"Check Brake System" Displayed in MID at Startup

Service Category Brake

Section Brake System

YEAR(S)	MODEL(S)	ADDITIONAL INFORMATION
2015 - 2017	Camry

Figure 2: Health Check Results

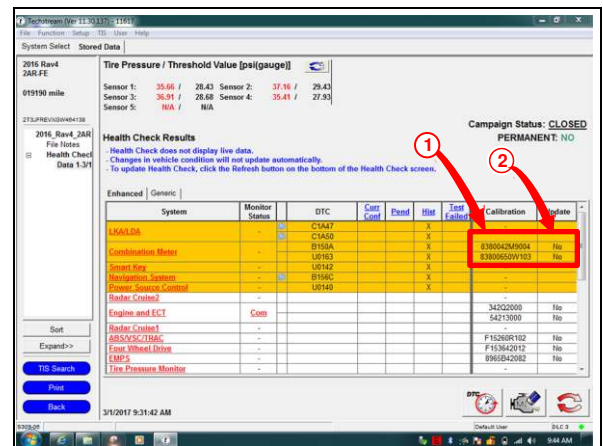
1	Current ECU Calibration
2	Indicates If Updated Calibration Available

4. Flash reprogram the skid control ECU with the applicable NEW Calibration ID as indicated in the Calibration Information table on pg. 2.
